**DISCUSSION OUTLINE
April 2, 2002**

**Prepared by
Ricondo & Associates, Inc.**

O'Hare International Airport

FUTURE AIRPORT DRAWING Option 1

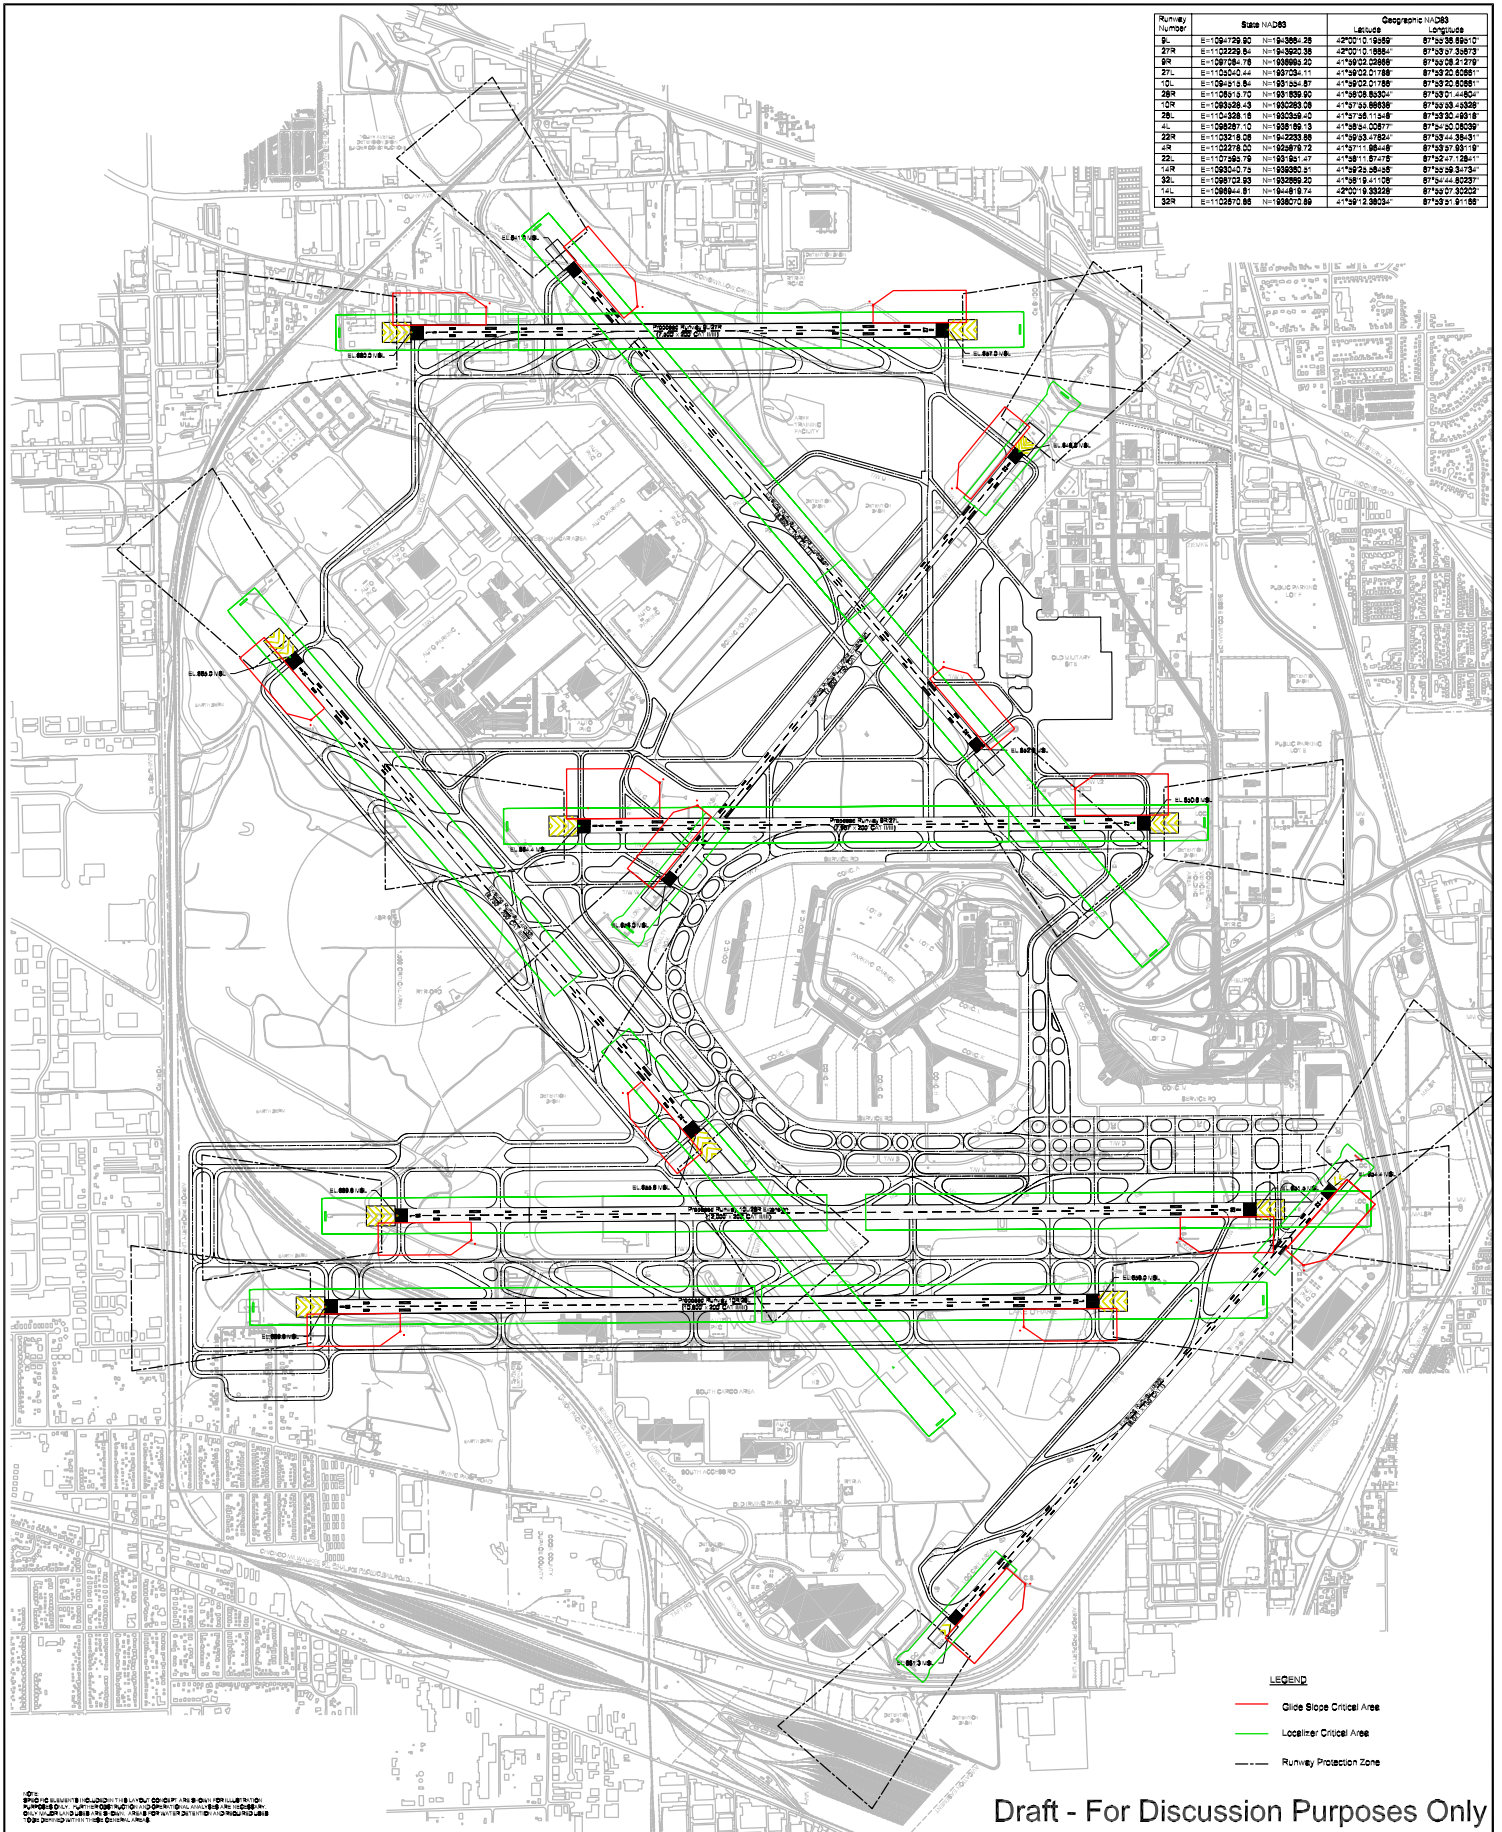
Revision 1 - Location west of Runway 10L:

Dual north/south perimeter taxiways are located west of the approach end of Runway 10L. The outer perimeter taxiway is located outside the Runway 10L approach RPZ. The inner perimeter Taxiway is located inside the Runway 10L approach RPZ and would have use limitations during certain runway configuration operations.

Revision 2 - Location south of Runway 10R approach RPZ:

A dual east/west taxiway section was added 324 feet south of the Runway 10R parallel taxiway. It connects the perimeter taxiway to the Runway 10R exit/entrance taxiway connector. This taxiway will permit the taxi flow of aircraft to operate outside the Runway 10R RPZ.

Revision 3 – Location south of Runway 10R approach RPZ :

A holding bay (hold pad) was added adjacent to the taxiway connector serving the west end of Runway 10R. This holding bay will provide a standing space for aircraft awaiting ATC clearance and permit those airplanes already cleared to move to their runway takeoff position while ensuring queuing aircraft will remain outside the Runway 10R approach RPZ.

Revision 4 – End Taxiway for Runway 22L:

An end taxiway had been proposed for Runway 22L for use in staging departures clear of Runway 28R arrivals. However, this taxiway cannot be developed without the staged aircraft being within the RPZ for Runway 28R. As such, it has been removed from the concept.

Design by:	Created by:				No.	Revisions	Date		
Drawing by:	Reviewed by:								
Project No: April 1, 2008 Sheet 1 of 1			<h1 style="margin: 0;">FUTURE AIRPORT DRAWING</h1> <h2 style="margin: 0;">Option 5</h2>

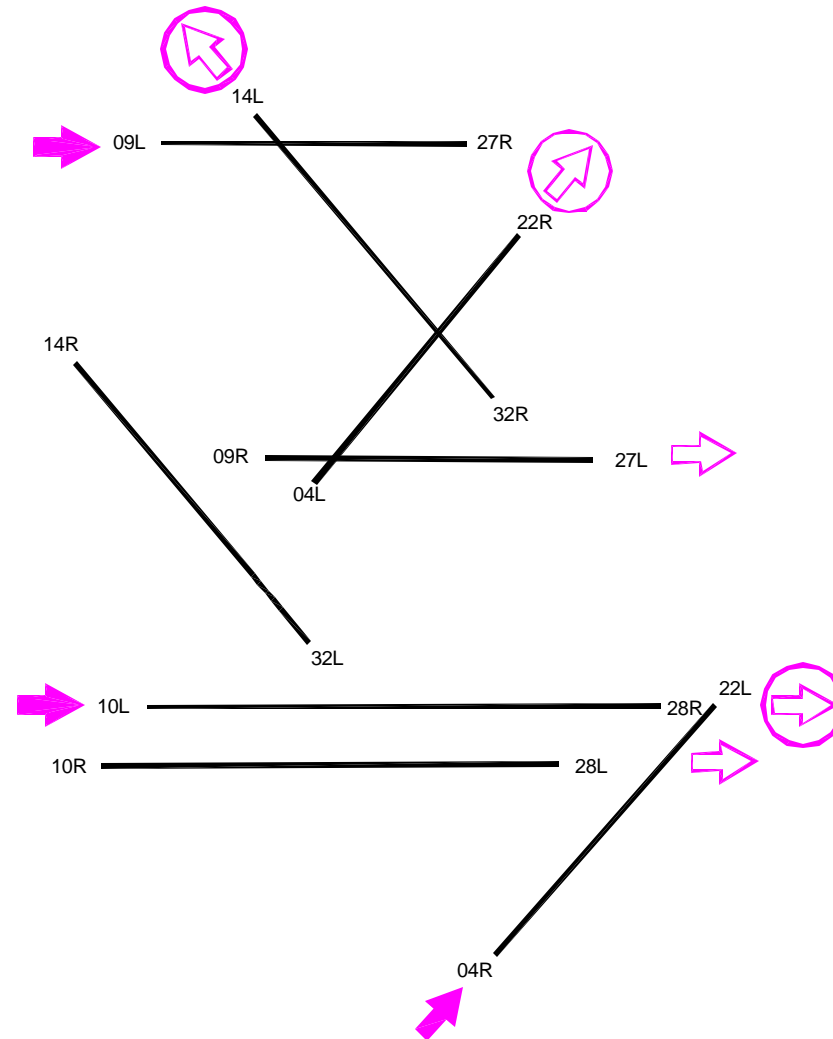
The west end of Runway 10L/28R is located further west than exists today and does not permit the construction of perimeter taxiways outside the Runway 10L/28R RPZs. By moving the Runway to the west, Taxiway S, in its current location, becomes a perimeter taxiway, however, it remains inside the Runway 28L RPZ. No revisions have been made to this Option.

Exhibit III-1

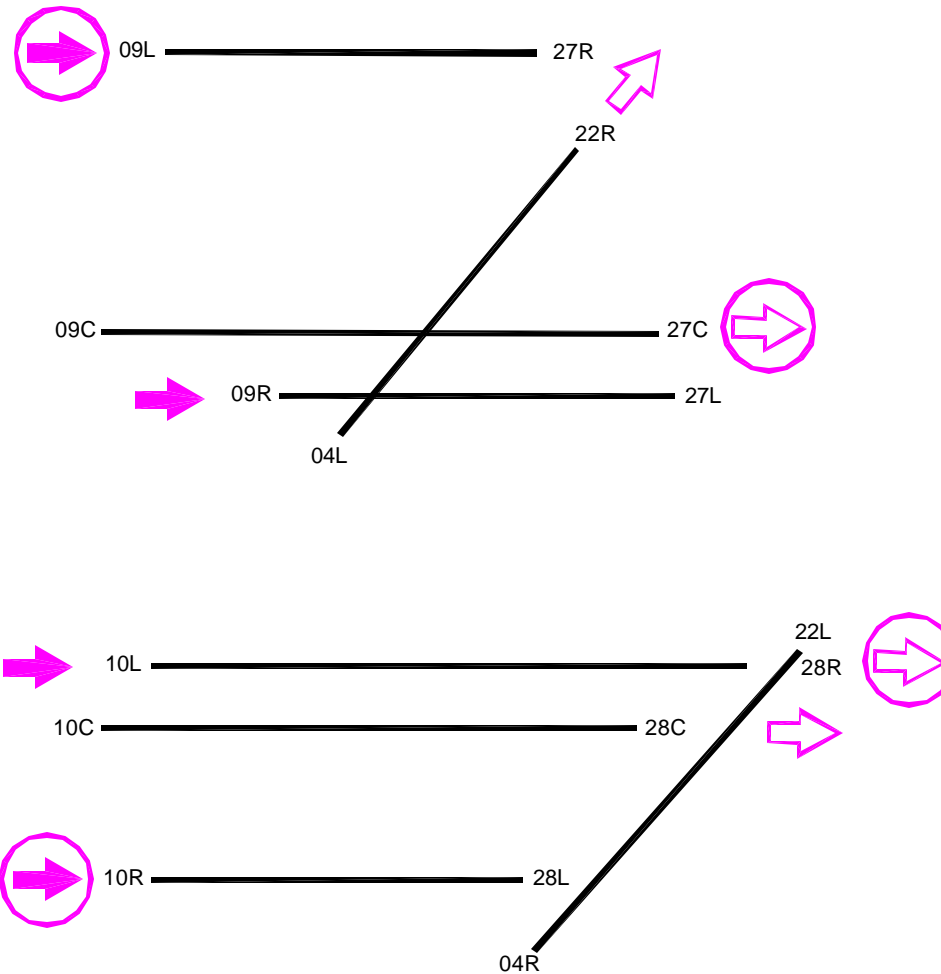
2. **Exhibit III-1** depicts Option 1, under which the airfield is operating to the east. As was initially proposed in Experiment 8 of the Experimental Design of March 5, 2002, arrival aircraft would expect Runways 04R, 10L, and either Runway 14R or Runway 09L. An arrival configuration using Runways 04R, 10L and 14R would preclude traditional routing of westbound departures without modifications of arrival descent ("dump-zones") for the arrival runways. The arrival configuration of Runways 04R, 10L, and 09L would allow westbound departures to be routed north of the Runway 09L dump-zone similar to present day procedures. Consequently, the arrival configuration currently being modeled in Experiment 8 is currently using Runways 04R, 10L, and 09L. Departures would expect Runways 09R, 10R, and 04L.

3. Runway 04R and Runway 10L are being utilized as the primary arrival runways. Runway 09L is used during periods of compacted arrival demand. Runway use strategies employed in Experiment 1, which attempt to maximize the use of Plan X Runways 09L and 04R, are currently being utilized for Experiment 8.

4. Westbound departure traffic over Iowa City VOR (IOW), Polo VOR (PLL), and Moline VOR (MZV) are currently being assigned Runway 04L along with the northbound fix of the Badger VOR (BAE). Aircraft departing over PETTY intersection and the eastbound departure fix of the Keeler VOR (ELX) are currently assigned to Runway 09R. Southbound fixes of GUIDO intersection, the Peotone VOR (EON), and the Roberts VOR (RBS), along with the Gipper VOR (GIJ), are currently assigned to Runway 10R. International departures destined to Europe are currently assigned to Runway 32R, while those international flights destined to Asia are currently assigned to Runway 10L.

5. The dependency of Runway 10R departures and Runway 04R arrivals is currently modeled such that Runway 10R departures may not takeoff until the Runway 04R arrival passes the extended centerline of Runway 10R.

- Should the airspace be designed that westbound departures would depart via the north portion of the west climb corridor, how many westbound departures can operate with approximately 8,000 feet of runway available?
- Should the arrival configuration of Runways 04R, 10L, and 14R be utilized, how would westbound departures be accommodated?

Exhibit III-2

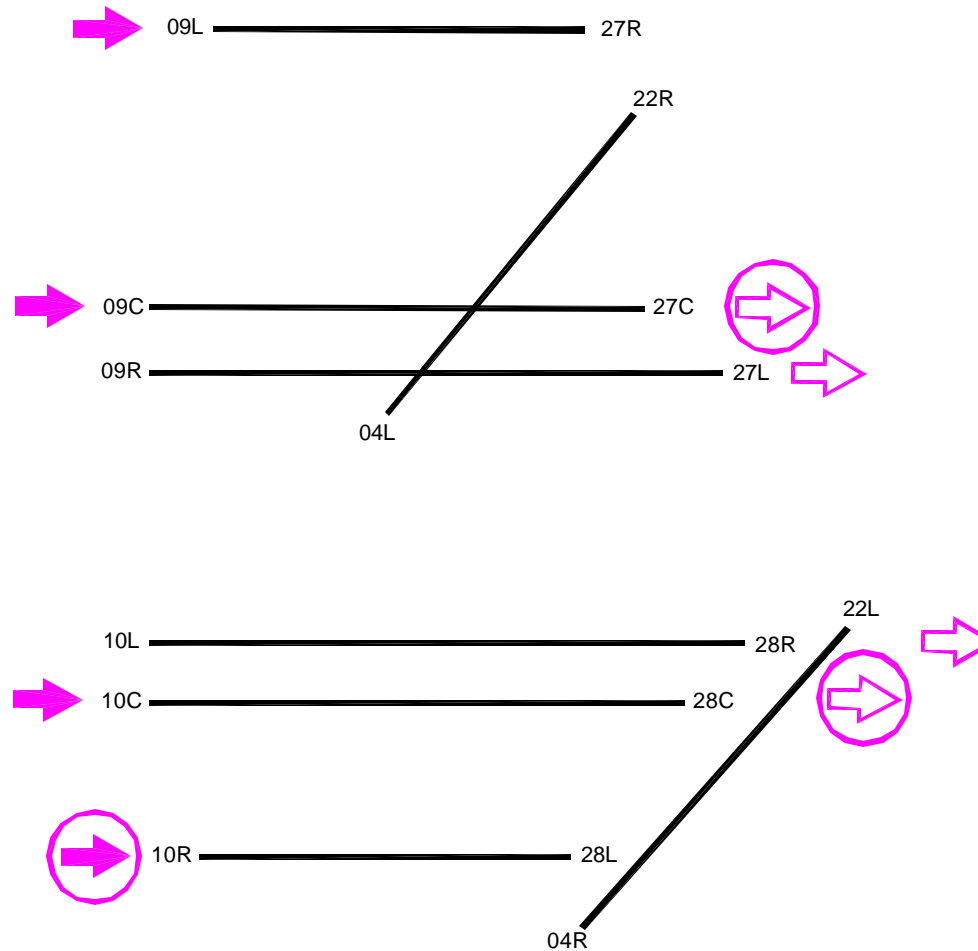
6. **Exhibit III-2** depicts Option 2, under which the airfield is operating to the east. As was initially proposed in Experiment 12 of the Experimental Design of March 5, 2002, arrival aircraft would expect Runways 09R and 10L with Runway 10R used during periods of compacted arrival demand from the south and Runway 09L used during periods of compacted arrival demand from the north. Departures would expect Runways 04L and 10C with Runway 09C and 10L available for periods of compacted departure demand and international traffic.

7. Westbound departure traffic over IOW, PLL, and MZV is currently being assigned Runway 04L along with the northbound fix BAE. Aircraft departing over PETTY intersection and the eastbound departure fix ELX are currently assigned to Runway 09C. Southbound fixes of GUIDO, EON, and RBS, along with the GIJ, are currently assigned to Runway 10C. International departures destined to Europe are currently assigned to Runway 10C, while those international flights destined to Asia are currently assigned to Runway 10L.

- Should the airspace be designed that westbound departures would depart via the north portion of the west climb corridor, how many westbound departures can operate with approximately 8,000 feet of runway available on Runway 04L?

- Should Runway 09C be used for departures, would heavy/B757 jet arrival traffic be excluded from Runway 09R to minimize the effects of wake turbulence due to the location of the arrival threshold of Runway 09R in relation to the departure threshold of Runway 09C?
